1.1 This Technical Note has been prepared by DTA Transport Planning Consultants on behalf of the applicant, Hargreaves to address transport comments raised by Hampshire County Council associated with planning application F/24/98415.

1.2 The applicant seeks permission planning application for construction of a 150m² coffee pod (Use Class E) on part of the car park associated with the existing Wickes DIY store at Unit F1, Hamilton Business Park, Hedge End, Southampton.

DRAWING TITLE
Vehicle Tracking Plan

SCALE	DRAWN BY	DATE	DRAWING No	REVISION
1/250@A3	BP	27-11-24	23448-02	a

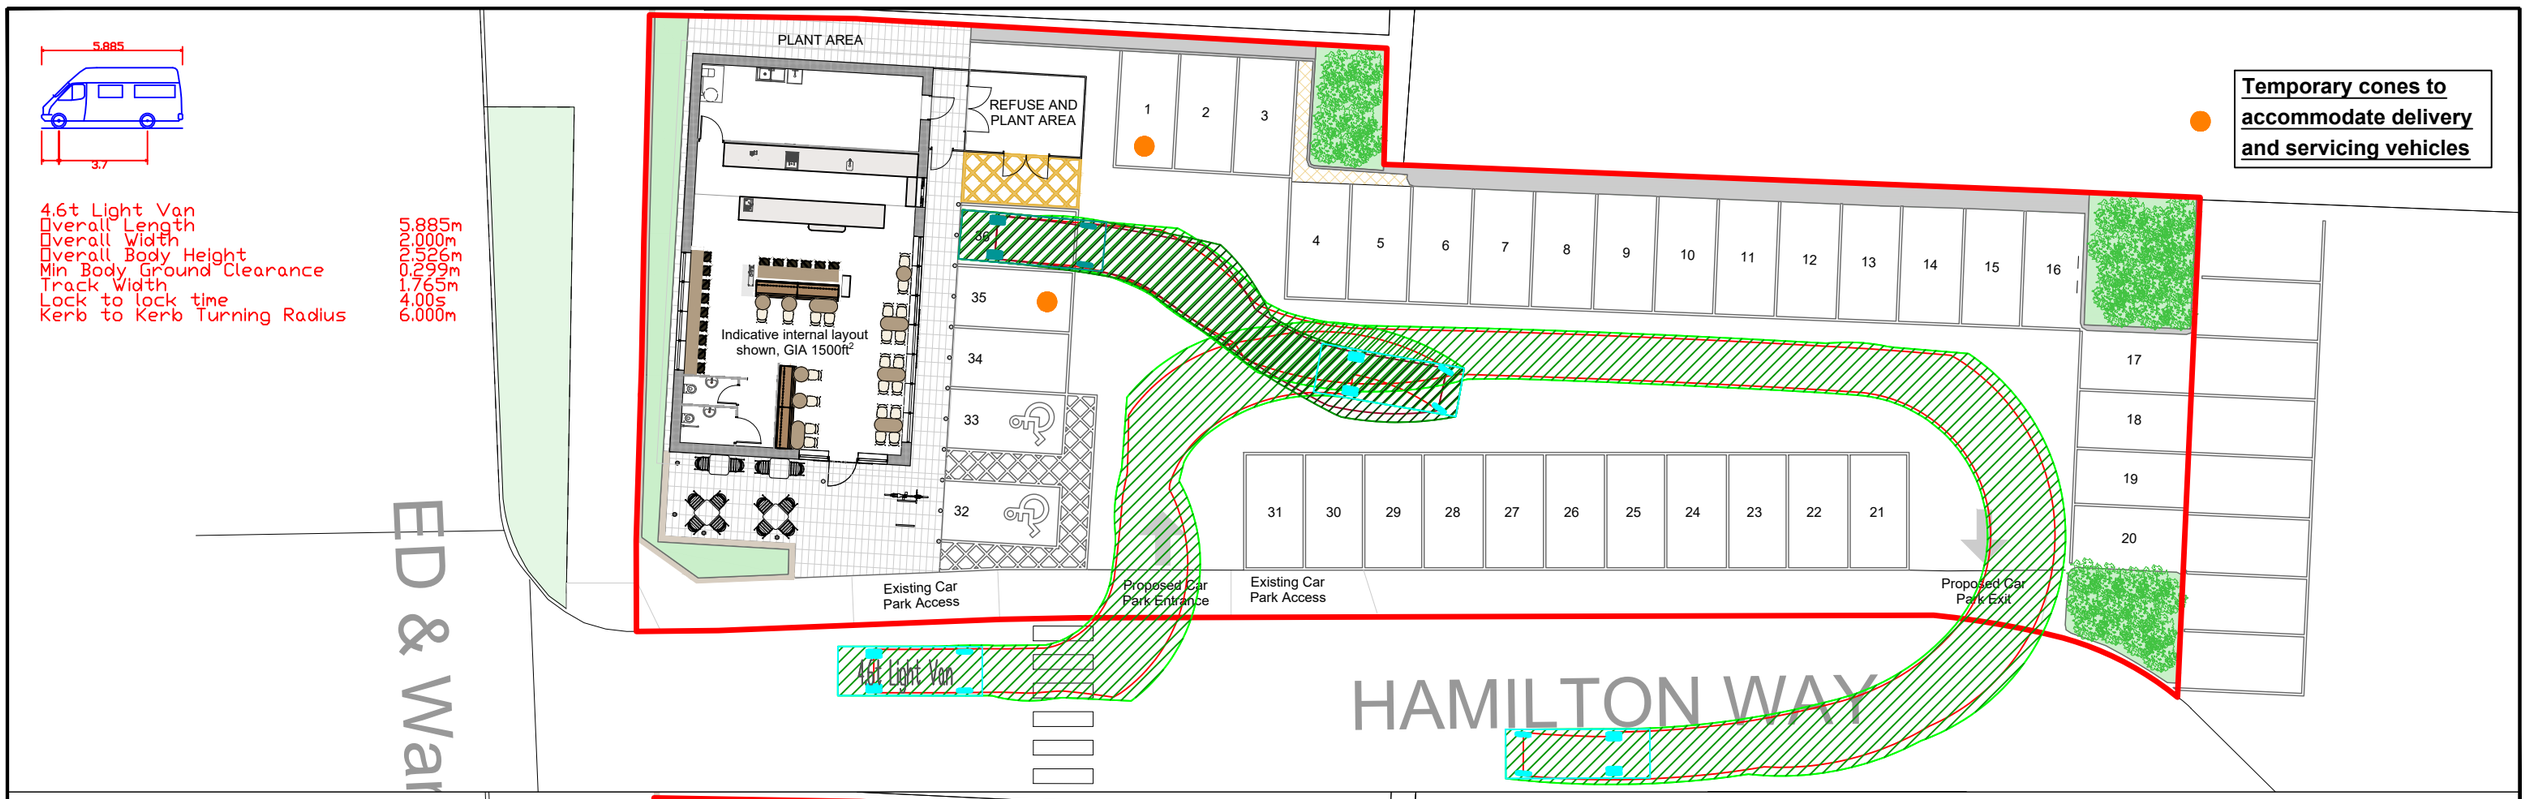
2.1 **HCC:** Servicing is outlined to take place on site, with 3 parking spaces needing to be closed off whilst the delivery vehicle is on site… Whilst this is acceptable in principle, it is noted that the vehicle tracking for both delivery vehicles and refuse vehicles on site, that in addition to the 3 parking spaces outlined for closure, it is likely that a further 3 outside the retail unit will be inaccessible, and that a further 2 spaces are partially driven across.

2.2 As such, it would be requested that the tracking exercise is revisited, with adjustments made if necessary to a) affect less parking spaces; and b) show how parking spaces can be parked in by vehicles even with refuse / delivery vehicles in place.

2.5 As requested, the swept-path assessment has been revisited and presented in **DTA Drawing 23448-02a** (delivery vehicles) and **DTA Drawing 23448-02-2a** (refuse vehicle). The assessments demonstrate the following:

- Both daily delivery vehicle and refuse vehicle can be accommodated within bay 36;
- the weekly HGV delivery vehicle can be accommodated across bays 35 and 36.
- The arrangement would result in a maximum of five parking spaces (spaces 1, 2, 3, 35 and 36) becoming temporarily inaccessible during the visit of the HGV delivery vehicle.
